RE: **Service Campaign 2021050008 Launch Notification**
Replace Seals on the Capacitor and Receiver Drier of the Air Conditioning System
MY20-21 118 (CLA-Class)

Campaign No. 2021050008, May 2021

SUBJECT: **Model CLA-Class (118 platform)**
Model Year 2020-2021

Replace Seals on the Capacitor and Receiver Drier of the Air Conditioning System

Figure 1

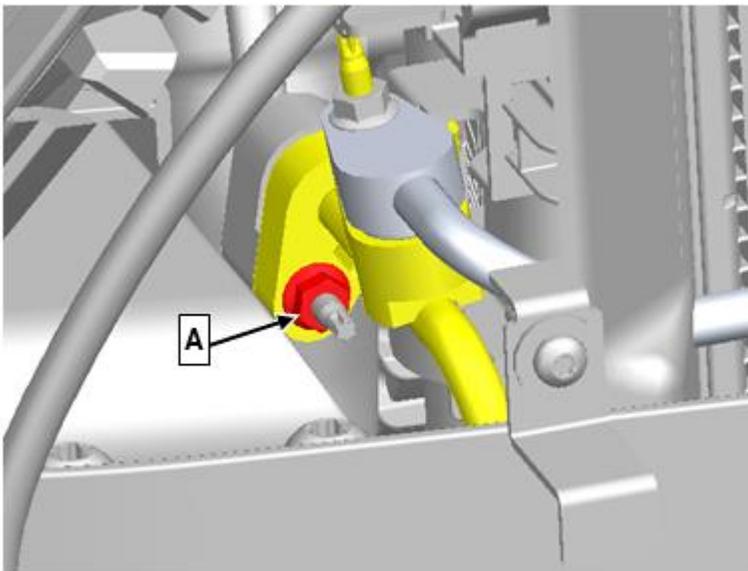
1. Empty air conditioning system, evacuate.
i For basic data, see **AR83.30-P-1760MFA**.
2. Remove front bumper.
i For basic data, see **AR88.20-P-2000MFA**.
3. Remove impact absorber from crossmember.
4. Loosen nut (**A, Figure 1**) on refrigerant line connection to right front pipe system and then tighten.
Nm Nut to right front pipe system: **12 Nm ± 1.2 Nm**.

Figure 2

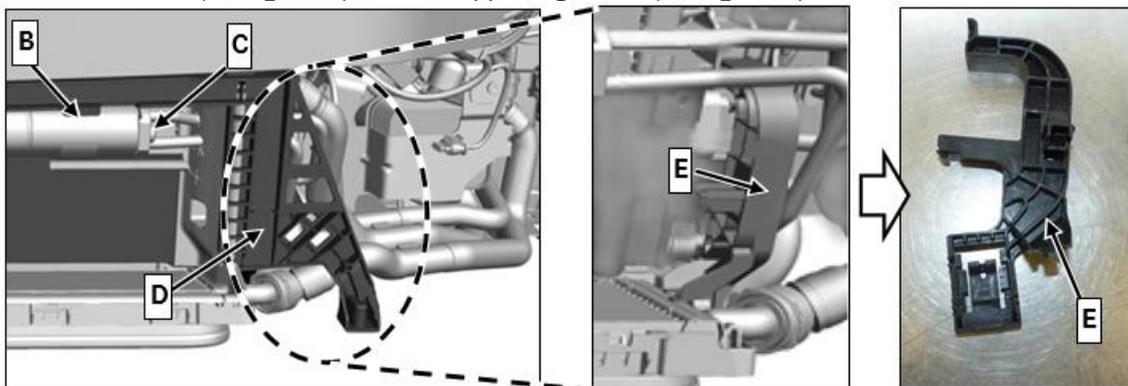
5. Unscrew the screw (**C, Figure 2**) at the receiver drier (**B, Figure 2**), then remove the holder for the refrigerant lines at the receiver drier (**B, Figure 2**).
Nm Screw for refrigerant line to receiver drier: **10 Nm**.
6. Remove bracket (**E, Figure 2**) behind supporting frame (**D, Figure 2**).

Figure 3

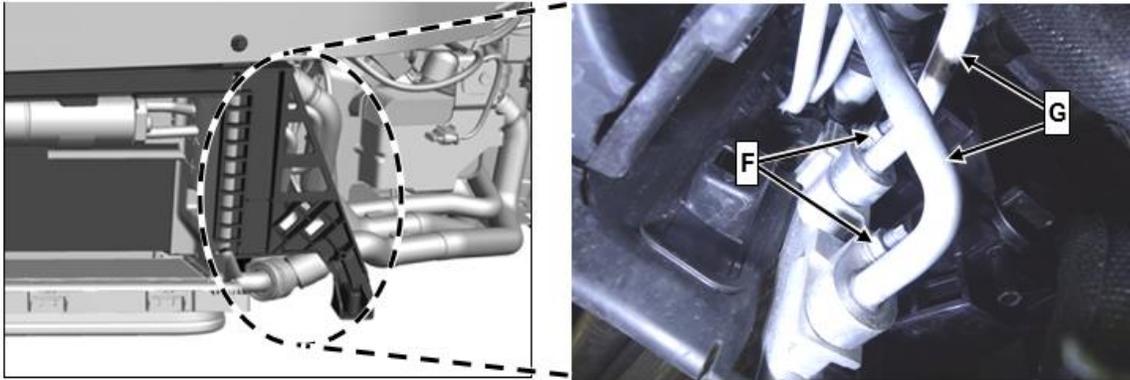
7. Unscrew nuts (**F, Figure 3**).

Nuts to refrigerant line: 12 Nm.

8. Remove refrigerant lines (**G, Figure 3**).

Figure 4

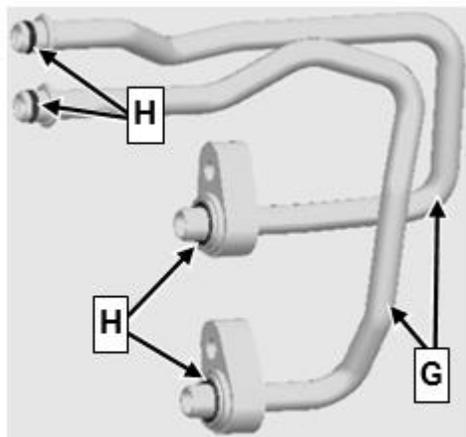
9. Replace sealing rings (**H, Figure 4**) of refrigerant lines (**G, Figure 4**).

Wet new sealing rings with compressor oil (**specification 362.1**).
